NONA PARK LOT 4 SPMP

The applicant is requesting Specific Parcel Master Plan (SPMP) approval for a 12,630 sq. ft. office and commercial use. The property is outparcel 4 of the Nona Park development.

Updated: June 24, 2015

SITE PLAN

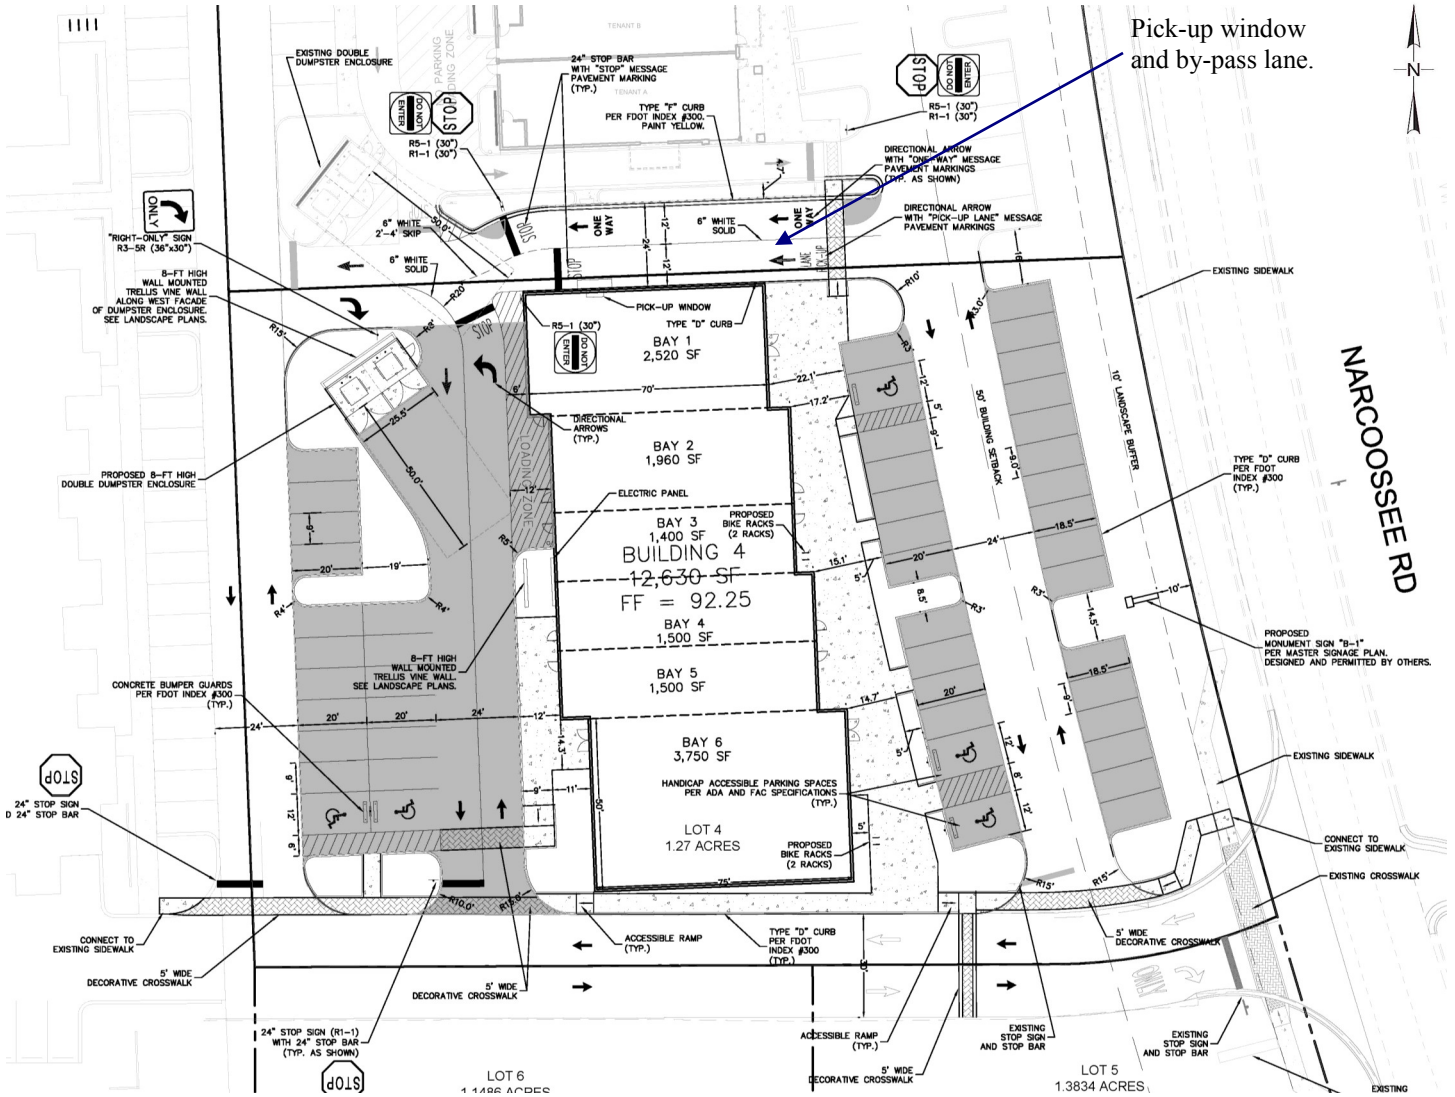
6. Parking Lot Landscaping. Three canopy trees shall be added to the rear parking lot.

2. Provide an additional pedestrian access from east/west connector road to rear of building.
3. Sidewalk connection off of Narcoossee Rd has very sharp turns that will make it difficult for the handicapped to maneuver. Provide smoother radii and get as close to perpendicular to the sidewalk on Narcoossee Rd as possible.

4. Provide 12" thick retro-reflective pavement markings parallel to and on each side of the crosswalks to provide higher visibility.
